IMS Systems, Inc.
10521 Perry Highway
Suite 310
Wexford, PA. 15090
(724) 940-7160 Main Office
(724) 940-7179 Fax

6 July, 2001

Mr. Bill Ward
Mechanical Engineer
United States Nuclear Regulatory Commission
Washington, D.C.

Enclosed is our response to the letter you sent us on 28 June, 2001. We have addressed the questions in the same order that you presented them. We hope that you find the inclusions satisfactory. Please accept our apologies for some confusion over the construction parameters and the use of German in some of the drawings. We wish to make your review of our requests as smooth as possible.

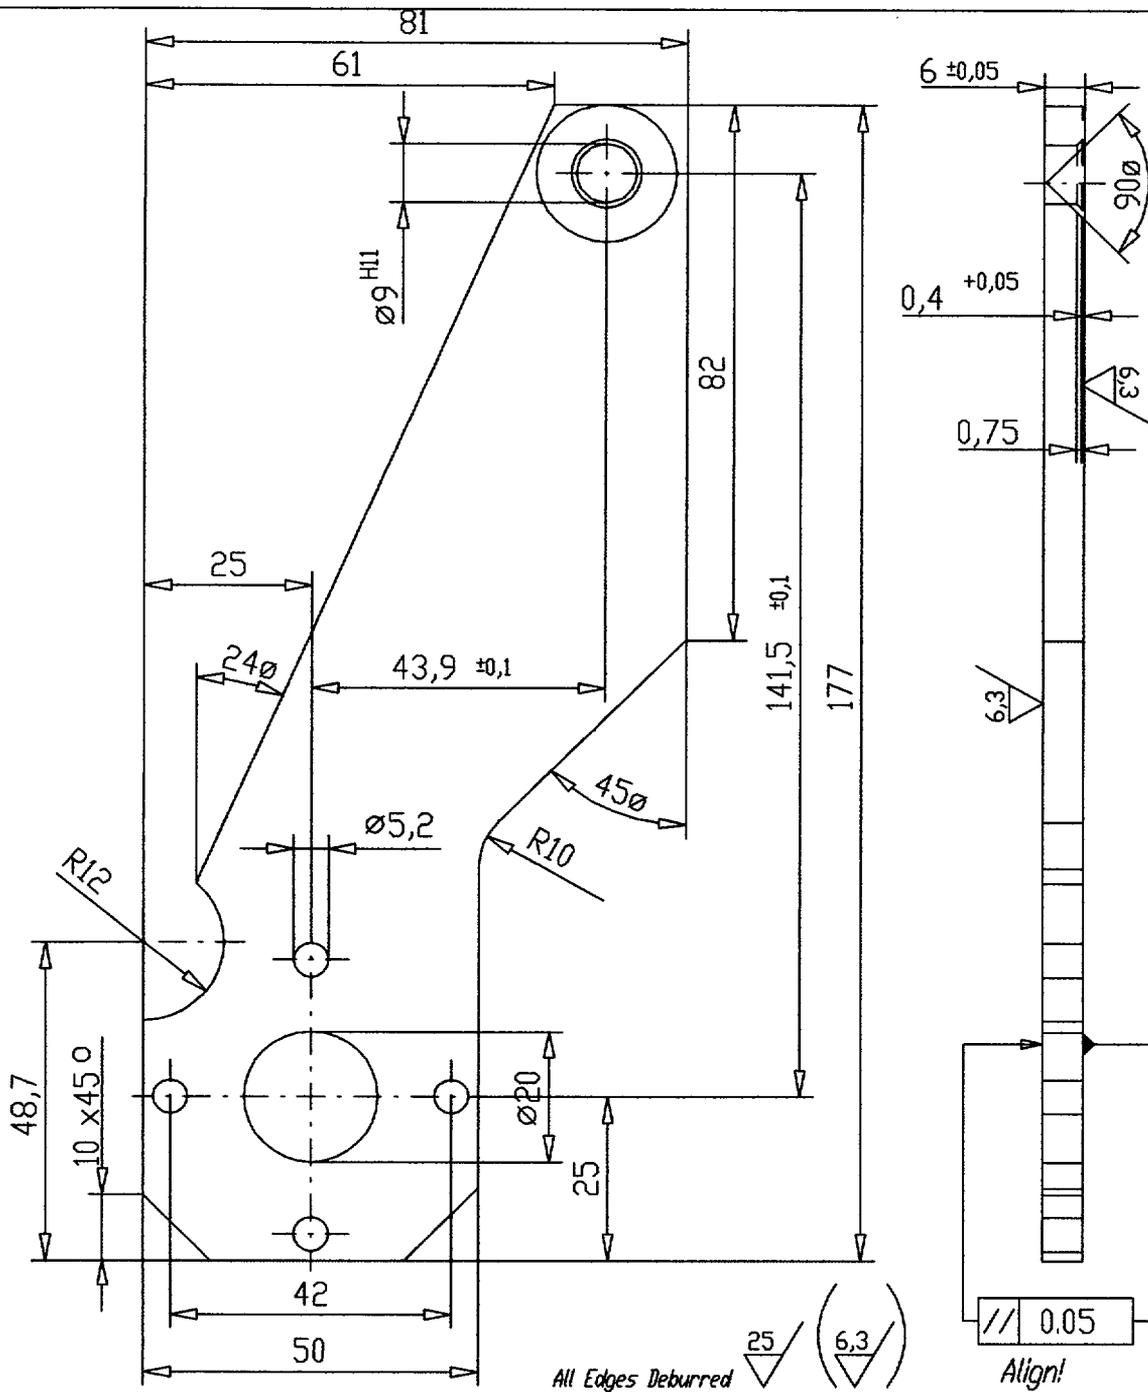
DIFFERENCE BETWEEN HOUSING DRAWING AND PICTURE: The NRC is correct (good observation). When the TIAS 212 assembly moved the detector geometry (see item 4.1), then the cylinder mounting bracket was re-designed. Due to the change, the old bolt hole pattern was difficult to access. Please see correct bracket drawing 5321-035-05

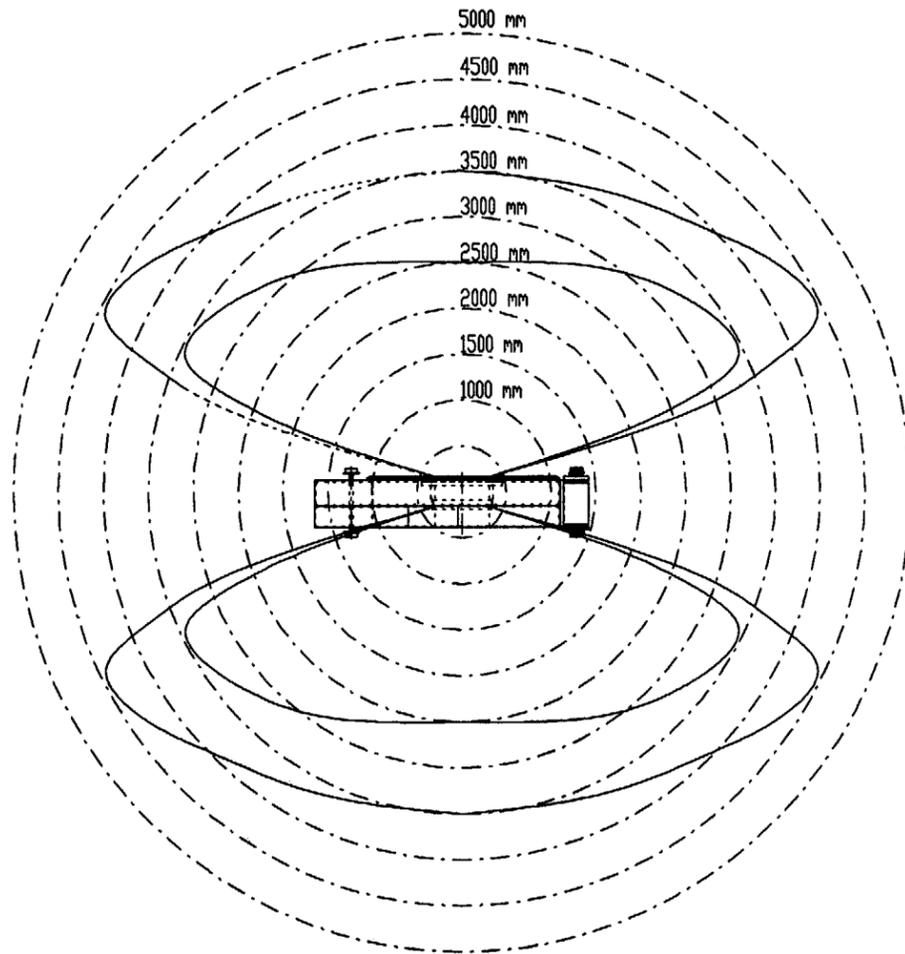
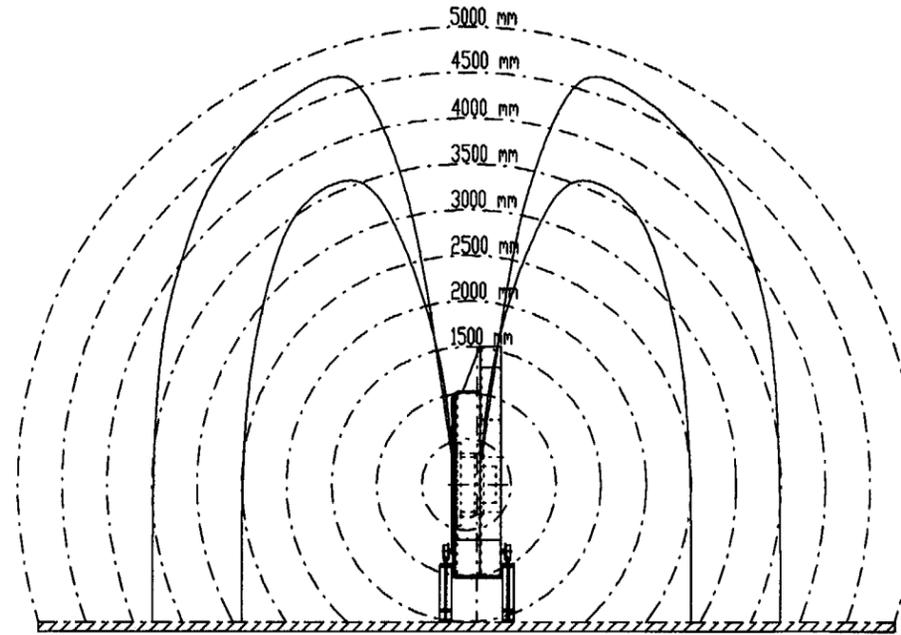
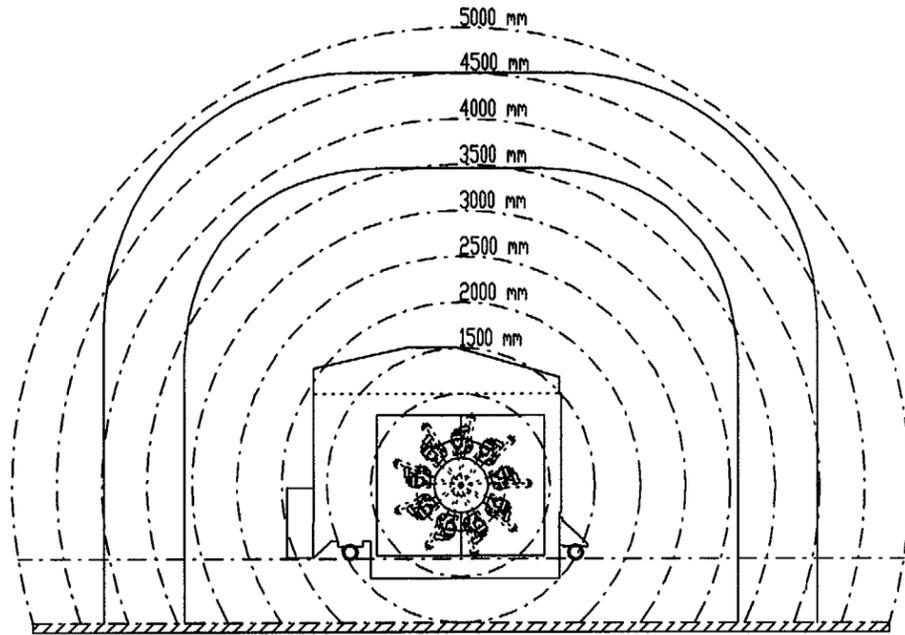
RADIATION PROFILES: Please see the attached isodose curves that are actual measurements around the gauge. As noted on page five of the ANSI testing section of the application, measurements were taken with a Babyline 31 system. The absorber information is:

300 mg/sq cm	removable cap
7 mg/sq cm	tissue equivalent (without cap)

There is no external dose when the shutter is closed. The exposure in this configuration is confined to the "O" part of the frame.
